Submissions Report

*Waterloo Metro Quarter -
Central Precinct (SSD-
79307746)*

March 2026

Prepared for: WL Developer Pty Ltd

Retail Area 3

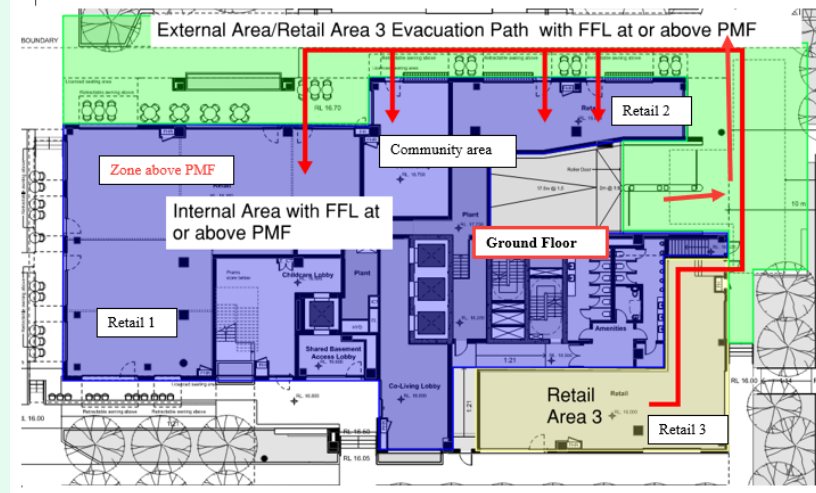
- B) Relocate the habitable use (building management office) from the basement
- C) Demonstrate how occupants of the Central Precinct south-western retail area could feasibly relocate to higher levels considering available warning time and mechanisms to provide warnings

A Flood Addendum has been prepared by WSP to address comments C - E and is enclosed in Appendix F.

Detailed procedures for occupant evacuation, including warning mechanisms, communication protocols, and expected warning timeframes, will be set out in the Flood Emergency Response Plan for the site. A draft Flood and Emergency Response Plan is included within the Flood Addendum. The draft Flood and Emergency Response Plan has been informed by the Shelter-in-place guidelines (CPHR, 2023) and engagement with NSW SES has commenced in relation to this document. WSP will continue to refine the Flood Emergency Response Plan in consultation with NSW SES following the determination of the Central Precinct SSDA.
